### Notice of specification change of MCCBs

- Molded Case Circuit Breakers NF1000-SEW 3P, NF1250-SEW/SDW 3P Front connection
- DSN Switches DSN1000-SW 3P, DSN1250-SW 3P Front connection
- ※ Special-purpose Breakers with the same model names are also included.

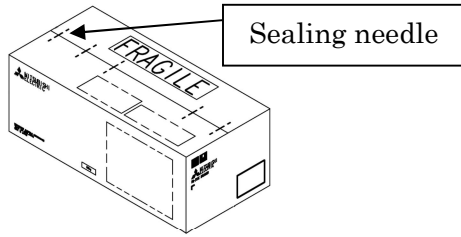
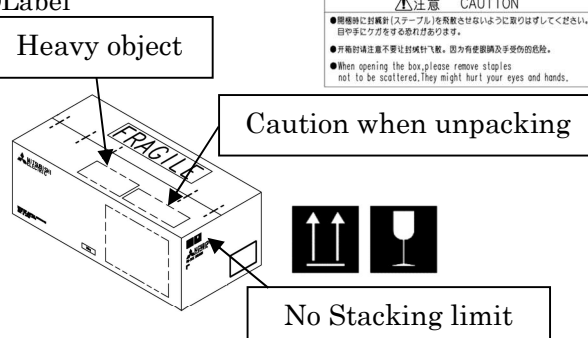
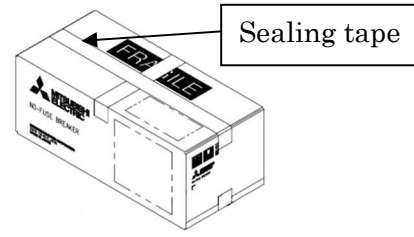
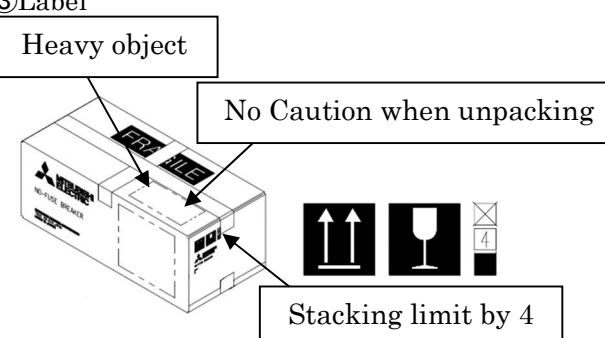
To change to packaging box size, sealing method, and label.

Before	After
<p>①Packaging box size(A×B×C) : 306×648×242</p>  <p>②Sealing method</p>  <p>③Label</p>  <p>Heavy object</p> <p>Caution when unpacking</p> <p>No Stacking limit</p>	<p>①Packaging box size(A×B×C) : 286×626×248</p>  <p>②Sealing method</p>  <p>③Label</p>  <p>Heavy object</p> <p>No Caution when unpacking</p> <p>Stacking limit by 4</p>
